UNITED STATES PATENT AND TRADEMARK OFFICE

APPLICATION NO.	FILING DATE	FIRST NAMED INVENTOR	ATTORNEY DOCKET NO.	CONFIRMATION NO.
10/783,520	02/20/2004	Stefan Peter Hau-Riege	IL-11154	7476

Office Action Summary	Application No. 10/783,520	Applicant(s) HAU-RIEGE, STEFAN PETER	
	Examiner Sang Nguyen	Art Unit 2877

DETAILED ACTION

FIG. 21

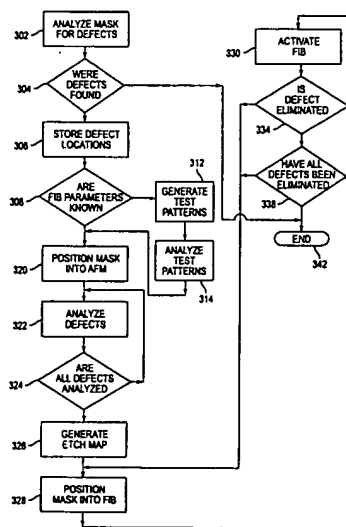
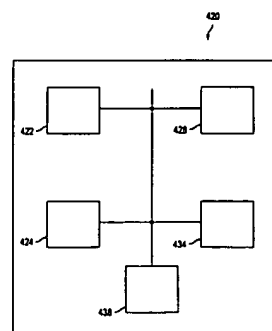
PAPI discloses all of features of claimed invention except for step of producing a three dimensional diffraction pattern from said series of two-dimensional diffraction patterns; computationally producing a reconstructed image of said sample from said three dimensional diffraction pattern; determining the location of said defect within said sample from said reconstructed image; and repairing said defect by applying an appropriate repair technique depending upon the location of said defect within said sample. However, Smith teaches that it is known in the art to provide a method and apparatus for repairing defect comprising producing a three dimensional diffraction

pattern (figure 15-16) from said series of two-dimensional diffraction patterns (figure 14) by an apparatus (420 of figure 21), wherein the apparatus having an analyzing (422 of figure 21), a three dimensional analyze means (428 of figure 21), a microprocessor (438 of figure 21), and correcting or eliminating means (434 of figure 21); computationally producing a reconstructed image of said sample (figures 15-16) from said three dimensional diffraction pattern by an analyzing (422 of figure 21) and a three dimensional analyze means (428 of figure 21); determining the location of said defect within said sample from said reconstructed image by a microprocessor (438 of figure 21); and repairing said defect by applying an appropriate repair technique depending upon the location of said defect within said sample by correcting or eliminating means (434 of figure 21). See figures 1-21.

Regarding claim 11; PAPI discloses all of features of claimed invention except for capturing said series of two-dimensional diffraction patterns prior to producing a three dimensional diffraction pattern. However, Smith teaches that it is known in the art to provide the apparatus (420 of figure 21) for capturing said series of two-dimensional diffraction patterns prior to producing a three dimensional diffraction pattern (figures 14-16). It would have been obvious to one having ordinary skill in the art at the time the invention was made to combine the method of PAPI with step of capturing said series of two-dimensional diffraction patterns prior to producing a three dimensional diffraction pattern as taught by Smith for the purpose of correcting and reducing of defects pattern on the photomask.

Regarding claims 16-17; PAPI discloses all of features of claimed invention except for said technique for image reconstruction from diffraction patterns comprises an iterative algorithm and a phase retrieval algorithm. However, Smith teaches that it is known in the art to provide said technique of the apparatus (420 of figure 21) for image reconstruction from diffraction patterns comprises an iterative algorithm and a phase retrieval algorithm (abstract and figures 14-16 and 29-21). It would have been obvious to one having ordinary skill in the art at the time the invention was made to combine the method of PAPI with step of said technique for image reconstruction from diffraction
